MEMORANDUM

From:	Built Heritage Officer		
Service	Green Infrastructure	App No:	261133 + 261134
Address:	Market Place		
Proposal:	261133 - Application for Listed Building consent for the proposed installation of two roof-mounted air source heat pump condenser units and associated plant, together with the erection of a roof-level fall- prevention guardrail at The Courtyard, Town Hall, Market Place, Wokingham. 261134 - Application for Listed Building consent for the proposed installation of two roof-mounted air source heat pump condenser units and associated plant, together with the erection of a roof-level fall- prevention guardrail at The Courtyard, Town Hall, Market Place, Wokingham.		
Heritage Asset:	Town Hall, including the Courtyard together hold Grade II* listed building status and are situated with the Wokingham Town Centre Conservation Area Listed Buildings along with Conservation Areas are classed as designated heritage assets under the NPPF and in the Council's Local Plan policies

Extract from Drawing No. 1323-Ww-B1-00-DR-A-0010: Proposed Site Layout

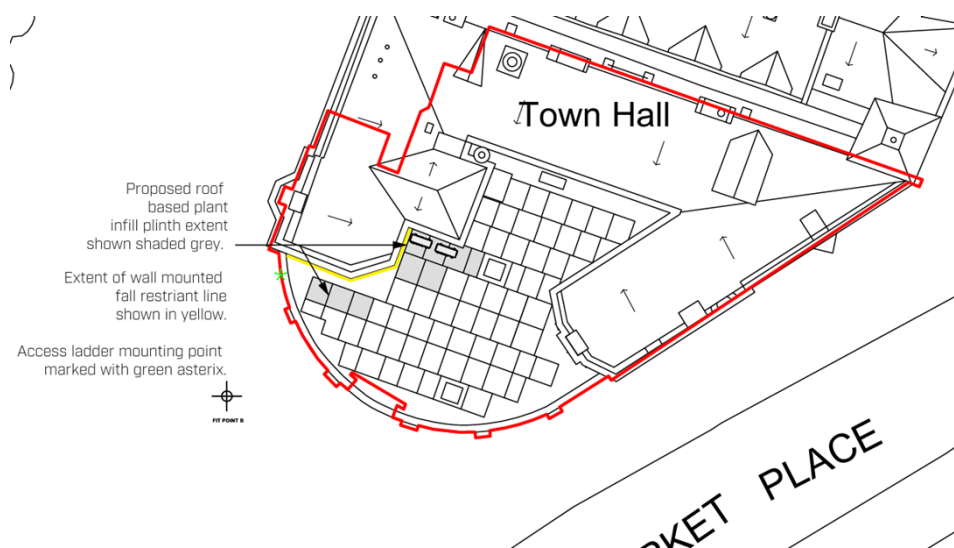
Following concerns raised as to the potential visual and physical harm resulting from the air source heat pumps being located as originally mooted and that of the intended safe working measures (fall prevention guardrails fixing points for an external ladder. It is now proposed to have installed the 2no. air source pump units on the opposing (western) side of the courtyard roof to that initially applied and would see the units sited further back on the roof from the curving external walling to the Courtyard

In the location, now being proposed, for the air source heat pump units it is considered the ability for the units to be seen from the ground would be greatly reduced compared to the previous location, where it is understood the units were to be mounted on structures over existing plastic barrel-vault rooflights that would have added the overall height the units would have. It being now proposed to site the units on infill plinths/flat boarded roof decking following the removal of existing plastic barrel-vault rooflights. With additional of the existing plastic barrel vault rooflights to be removed from around the units and adjacent to access point to the roof in so negating seemingly the previous intended fall prevention guardrails positioned that from a heritage stance were considered detrimental to the appearance of the listed building, whilst now also hopefully now allowing for more discreet safety measures in the form of a stainless-steel safety wire system intended to be attached (in six locations) into the brickwork of the Town Hall itself where it should be ensured the fixing points are kept low on the walling so as not to be visible from ground and from around Market Place.

With respect to the proposal for a removable ladder access to the Courtyard roof with fixed anchoring points on the external walling, which from the revised submitted proposed elevation drawings is to be sited close to the junction with that of the Town Hall and would be in the vicinity of a fixed bench situated adjacent to the walling and that of fixed water standpipe. Of more concern here is the intention for the anchoring points of the removable ladder to be fixed into the decorative band of brickworks at the top of the courtyard walling. The number of fixing points and precise location for these is not made clear in the submission sufficient to be able to access the potential harm that may result. At this point it is acknowledged that at the Built Heritage suggestion the proposal is now for a black finished eyebolt which is expected to be more recessive in appearance than a stainless steel finished one with broad collar to it, especially where the fixing point be to the black bricks. A further point of concern at this point with the form of the removable ladder having not been stated is with the decorative nature of the brickwork to the top of the Courtyard walling and the copings topping it, that these could become damaged were an inappropriate ladder to be used and/or measures to ensure the decorative brickwork is protected whilst the ladder is in use.

With the revised proposals when compared to the initially submitted intentions, the proposals are considered to result in a lesser visual detrimental impact in terms of the historic appearance of the Town Hall complex of roof mounted equipment on the Courtyard being visible from the ground in Market Place. The required fixings for the intended safety equipment needed for safe working on the roof will it is considered cause harm not just from the need for the fixings to be physically made directly into the external ornate brickwork, not just as the result of the harm this will cause to the historic brickwork but also as these fixings well have an unwelcomed visual impact. In having a detrimental

With the revised proposals, when compared with those originally submitted, the visual impact arising from roof-mounted plant on the Courtyard roof is considered to be reduced. The repositioning of the air source heat pump units and removal of a number of existing rooflights will lessen their visibility from ground level within Market Place and therefore reduce the degree of harm to the historic appearance of the Town Hall complex.

Notwithstanding these improvements, the proposals would still result in harm to the significance of the Grade II* listed building. In particular, the installation of fixings associated with the proposed roof access and safety systems would require direct intervention into areas of historic decorative brickwork. This would result in physical harm to historic fabric and introduce visual elements that would detract from the architectural character of the building

Notwithstanding the details submitted, the stainless-steel safety wire system shall be installed at a level below the top of the decorative brick parapet walling surrounding the Courtyard roof. All fixing points shall be located within the mortar

joints of the brickwork and shall not be fixed into the bricks themselves, unless otherwise agreed in writing by the Local Planning Authority prior to the commencement of the works.

Notwithstanding the details submitted, no works associated with the installation of the anchoring fixing points for the external safety ladder shall commence until details showing the precise location, specification and method of fixing within the external brickwork of the Courtyard have been submitted to and approved in writing by the Local Planning Authority. The works shall thereafter be carried out in accordance with the approved details.

Notwithstanding the details submitted, no works associated with the installation of the sitesafe external ladder or its fixing points shall commence until full details of the ladder, together with measures to ensure that its installation and use will not result in damage to the decorative parapet brickwork or coping stones of the Courtyard walling, have been submitted to and approved in writing by the Local Planning Authority. The ladder and associated protective measures shall thereafter be installed in accordance with the approved details and shall be retained and maintained as approved whilst access to the Courtyard roof is required or unless otherwise agreed in writing by the Local Planning Authority prior to changes being made.

Notwithstanding the details submitted, no external works shall commence until a methodology statement has been submitted to and approved in writing by the Local Planning Authority. The methodology shall include:

- a) Details of how access to the Courtyard roof is to be achieved for the purposes of altering the roof and installing the air source heat pumps, including details of any temporary protection measures required to safeguard the historic fabric.
- b) Details of the removal of the existing plastic barrel-vault rooflights and their replacement with a flat boarded roof deck, including construction methods and materials, to provide a suitable platform for the air source heat pump units and safe access for ongoing maintenance.
